# Access Compliance Report

## Public Rights-of-Way

| Intersection ID: 42950                  | Main Street: BENZIGER_CT | Cross Street: LONG_PAW_LN               | Location: NE           |
| ADA ID: 19019A22B57D                    | Ramp Type: PerpDiag      | Initial Pass/Fail: Fail                 | Overall Compliance: No |

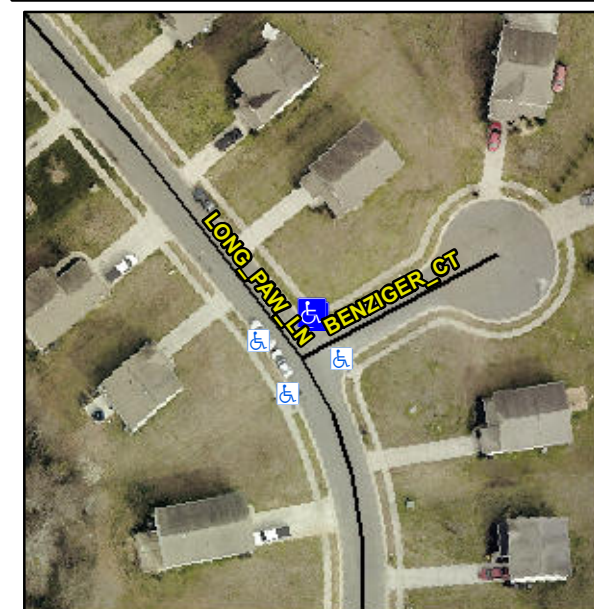
**Not Found, R304.5.1**

| Compliance | Description           | Data | Compliance | Description                 | Data |
|------------|-----------------------|------|------------|-----------------------------|------|
| No         | Ramp Width (in)       | 47.0 | Yes        | Ramp XSlope (%)             | 0.6  |

**Remove & Replace Curb Ramp With Two New Directional Ramps or Equivalent.**
